UNITED STATES PATENT AND TRADEMARK OFFICE

APPLICATION NO.	FILING DATE	FIRST NAMED INVENTOR	ATTORNEY DOCKET NO.	CONFIRMATION NO.
10/804,012	03/19/2004	Jae-ryong Park	1572.1220	8189

Office Action Summary

DETAILED ACTION

Segment of Fig. 12 from Davis (note the examiner has added the darkened arrows and the terms "groove" and "L-shape portion").

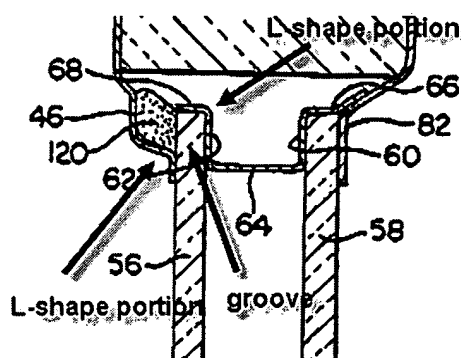
"L" shapes formed by either of portions (46) and portions (68, 62) are considered to form a groove that contacts and receives a window portion (56). As segment of Fig. 12 of Davis has been reproduced below and is considered to more clearly identify the grooves and L-shapes of the window accommodating part as relates to window portion (56).

As shown in this segment (and Fig. 12 of Davis), the window portion (at least 56) is fittingly inserted into the groove as recited. This window portion (56) is further considered to be contacting the periphery of the opening (note opening formed between leftmost channel 46 and rightmost peripheral lip 82).

In regard to the limitation of the supporting member and attaching the member (claims 1 and 13), Davis clearly shows that plate part (64) includes a supporter (at least 60 and spring flange 68) integrally formed with the plate part extended from a periphery of the opening (see Fig. 12) that function to support the window against the inner cover (see col. 4, lines 1-6).

However, the examiner notes that, as shown in Figs. 12 of Davis, gasket is only a small element that does not contact window (58) at all. While this gasket does contact window (56), as clearly

shown in Fig. 12, the window (56) in addition to contacting gasket (120) also contacts the end of channel (46) which is regarded as a periphery of the opening of the inner liner (48). Therefore, contrary to applicant's assertion, the window (56) contacts the periphery of the opening of inner liner (48).
